**SUBJECT: Oakland Harvesters (Preliminary Site Plan)**

**RE: Oakland Weed Harvesters - Preliminary Site Plan Review- 2<sup>nd</sup> Review**

**Subject:** Oakland Weed Harvesters  
Preliminary Site Plan Review #2  
Zoned: Light Manufacturing (LM) District

**Subject:** Oakland Harvesters  
Special Use Review #1  
Zoned: Light Manufacturing (LM) District

**SITE PLAN**  
 PARCEL NO. 12-01-127-001  
 WHITE LAKE TOWNSHIP, OAKLAND COUNTY, MICHIGAN

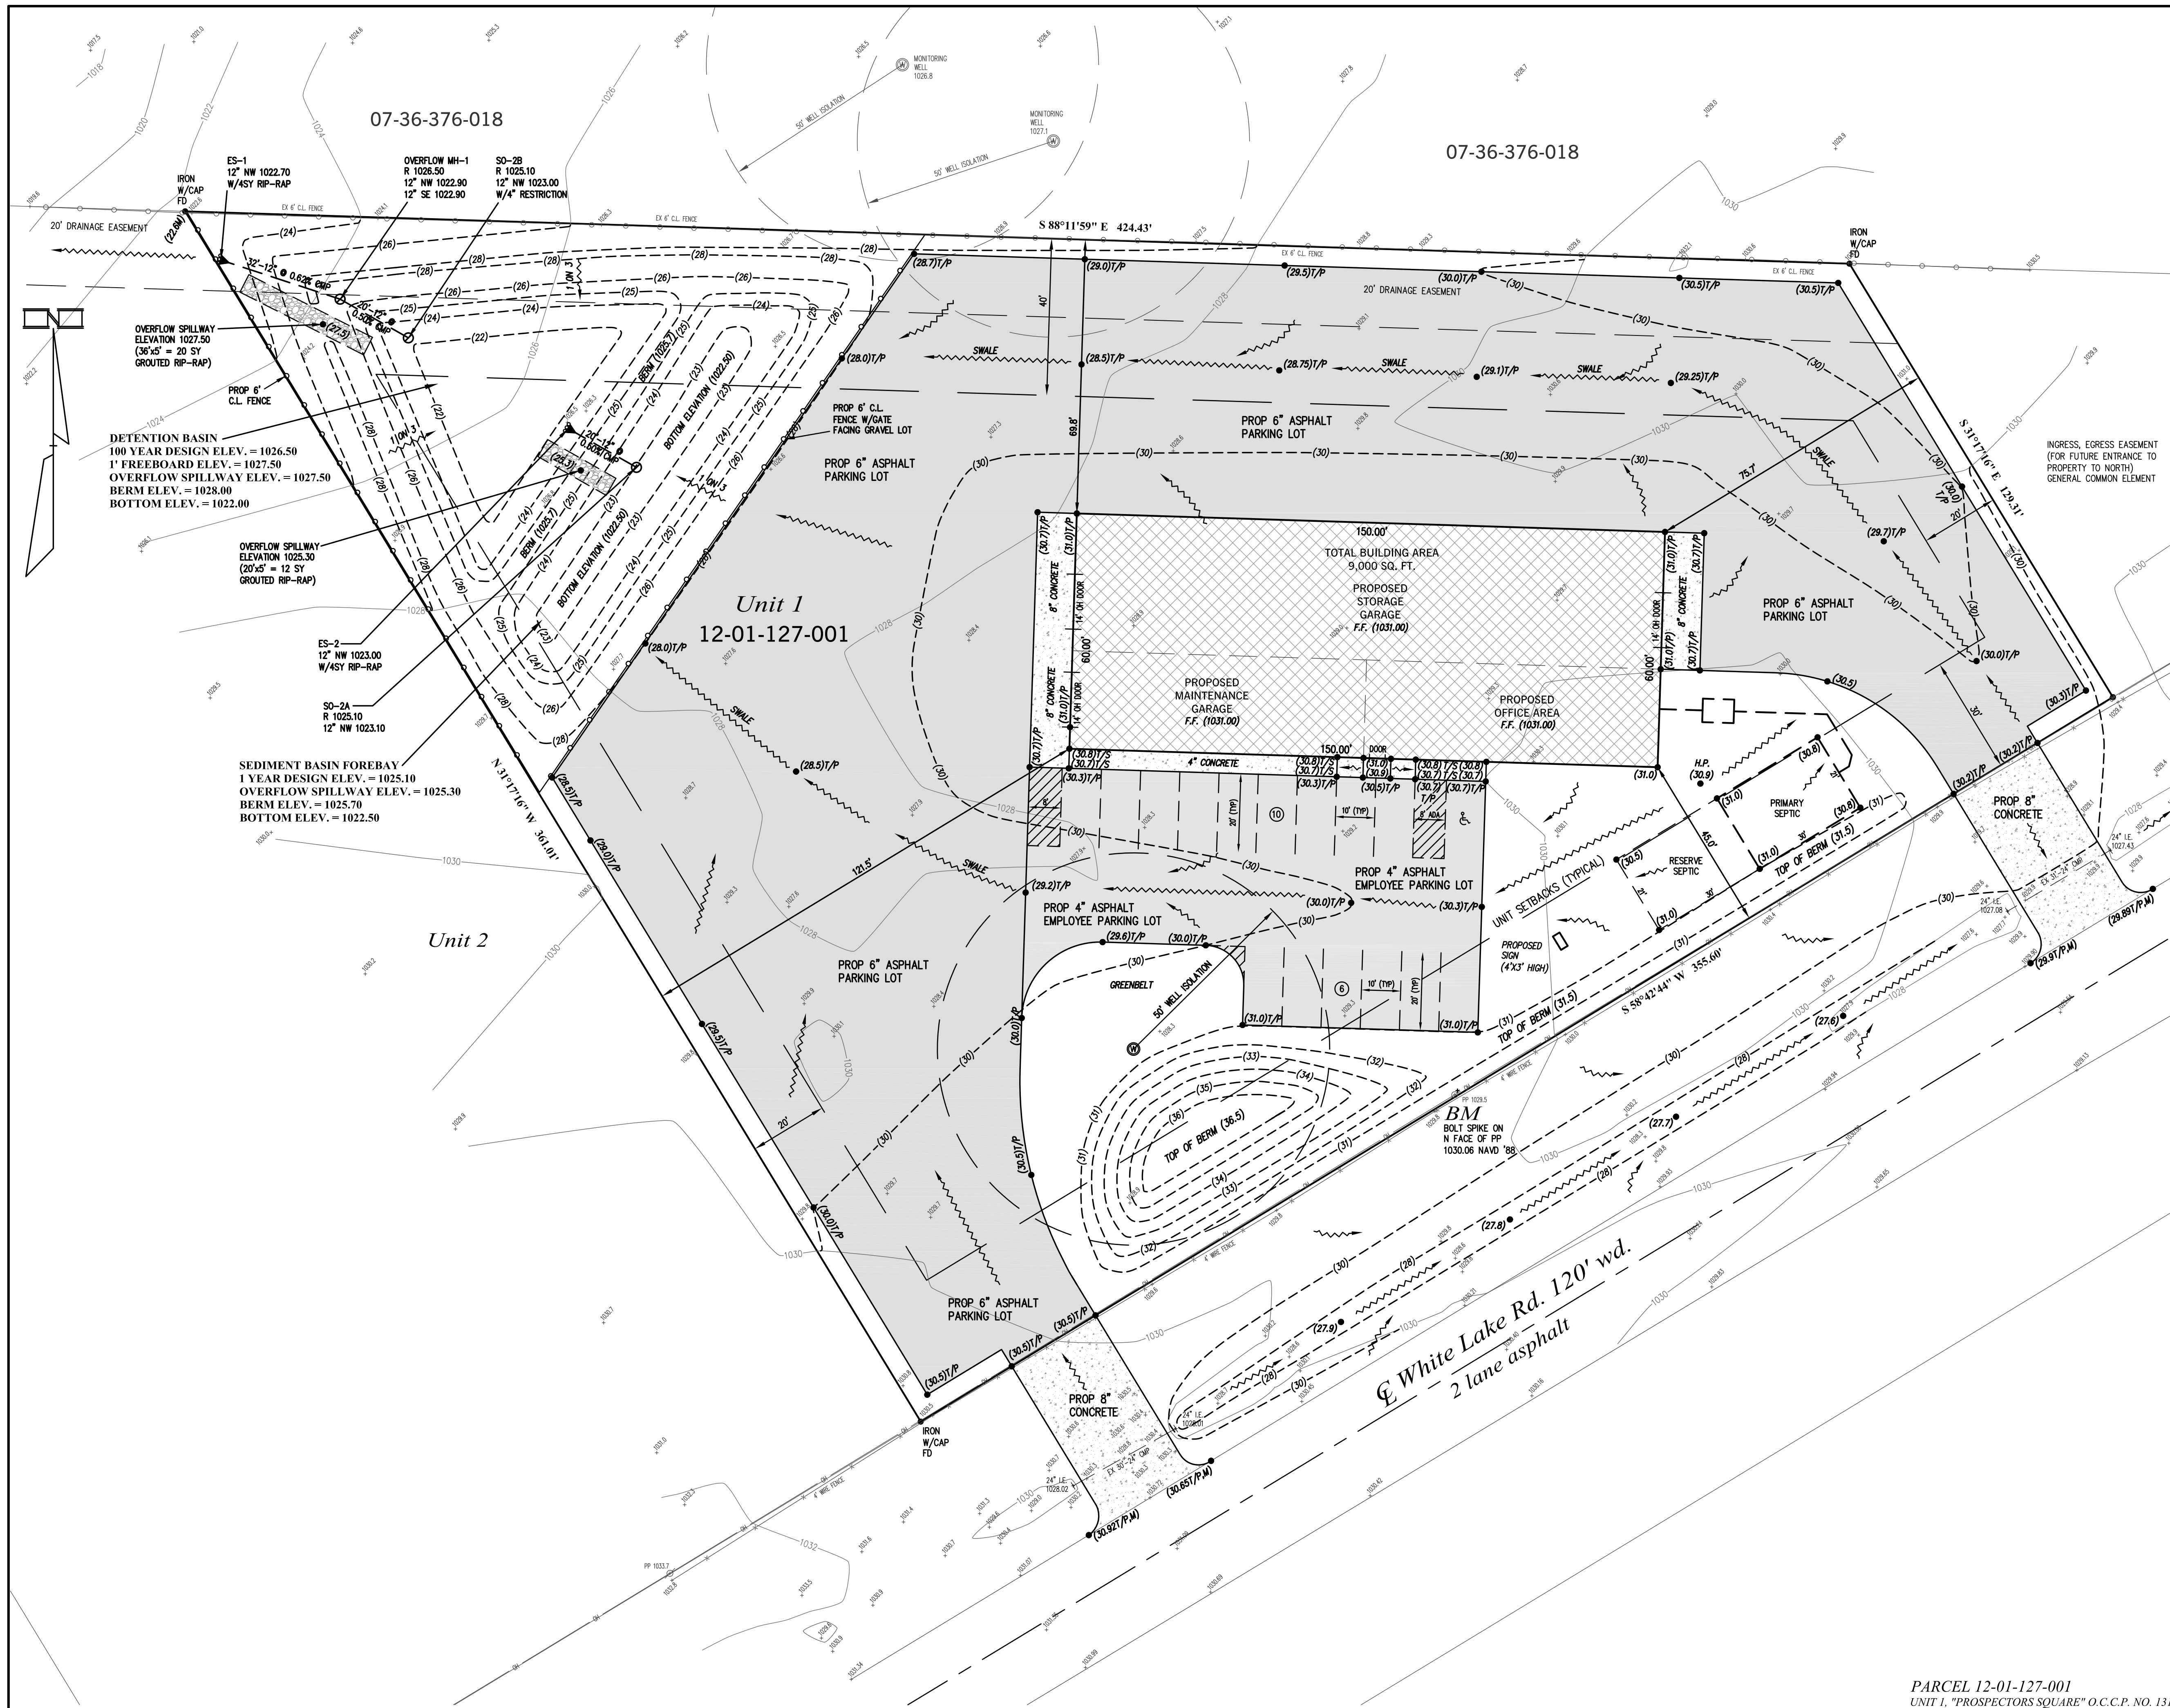
1. *The plan proposes gravel as the surface material for the parking and vehicle traffic areas in lieu of pavement material such as concrete or asphalt. Per White Lake Township Zoning Ordinance 5.11 Q. xi., all parking areas are required to be paved unless a variance is obtained. Should a variance not be approved, and the applicant required to pave the areas in question, would result in an increased area and volume required for the detention basin. **Comment addressed. All parking and vehicle traffic areas are now proposed to be paved. The detention basin calculations have now been updated to reflect this change; we are satisfied with the preliminary basin design calculations.***

2. *Maneuvering lane between parking spaces does not meet the required 24' width per Township Ordinance. **Comment addressed. Width of maneuvering lane is 24'.***

3. *ADA spaces and ramp will need to be provided per Township requirements. ADA parking spaces and ramps will need to be paved and meet all requirements of the Township and ADA. **Comment addressed. ADA parking spaces and ramps have now been provided.***

4. *Per Township Zoning Ordinance 5.11 Q. xvii. Concrete curbing or a raised sidewalk or parking bumpers shall be placed 3' off any building with adjacent parking. Please provide one of the above on plan. **A 4' wide raised sidewalk has been added between the building and the parking stalls, however Township Zoning Ordinance 5.11 Q. xv indicates a 7 foot wide sidewalk is required if the sidewalk is intended for pedestrian use to account for the subsequent vehicle overhang.***

5. *We note that Township Zoning Ordinance 5.19 B.V indicates that all required landscape areas which abut vehicular drives, parking, or other use areas shall be separated from the vehicular use area with a 6 inch minimum concrete curb. We defer to the Planning Department or Planning Commission on how this should be applied for this use. We note the plans propose sheet drainage to the sediment forebay which would not allow for continuous curb along the detention basin.*
-

6. We note that the plans do not propose a sidewalk along the White Lake Road Frontage, we defer to the Planning Department regarding this as a requirement for this development.

1. *The discharge for the proposed detention basin is not taking the intended easement path toward the ultimate outlet in the rear of the overall Prospectors Square development. This is per the Prospectors Square plans, Master Deed and Exhibit B documents. Furthermore, the proposed point of the basin discharge suggests that flows will enter on to off site property located in Springfield Township which would not be allowed unless a drainage easement is secured. This also applies to future flows from proposed basin spillway location.* **Comment addressed, design engineer has adjusted the outlet location and shown drainage flow lines within the drainage easement, this meets the requirements of PSP review. At the time of Final Site Plan/Final Engineering Plan submittal further detail will be required to demonstrate that the basin discharge will be confined within the drainage easement.**

2. *The proposed detention basin shall have a sediment forebay consistent with Township and Oakland County standards.* **Comment addressed. A sediment forebay is now proposed.**

4. **Site Circulation and Parking.** Manufacturing uses are required to have five (5) parking spaces plus one (1) for every one and one half (1 1/2) employees. The petitioner states that he will have eight (8) employees. This should be noted on the site plan. A total of 11 spaces are required. The petitioner is proposing 16 spaces. However; a portion of the parking along the White Lake Road frontage is in the required front yard setback. **These spaces should be removed.**

5. **Pedestrian Circulation.** Per Section 5.21 of the Zoning Ordinance, a six (6) foot wide public sidewalk is required along White Lake Road. The applicant has not proposed such a pathway on the submitted site plan.

9. **Trash Disposal.** The petitioner verbally indicated that they will have a refuse container, approximately 8' x 30' or 40'. No trash enclosure area is noted on the site plan. **If a dumpster or similar receptacle is planned for the site, the location and size should be noted on the site plan.** Dumpsters cannot be located closer to the front lot line than the principal building. Like building elevations, screening details should be provided and must comply with the standards insection 5.19(N) of the Zoning Ordinance for location, screening method, and enclosure standards.

Grading/Paving Item #4 Our plan specifies 18' parking spaces, and no cars are 20' in length, so there will be no vehicle overhang meaning the proposed sidewalk should be fine.

Grading/Paving Item #6 We will indeed add a sidewalk out front, and look forward to doing so if/when it becomes logical. Right now it would be a sidewalk to nowhere, and an added expense we would like to put off until it is really needed.

**The addition of the required six-foot public sidewalk should be condition of approval for the site plan.**
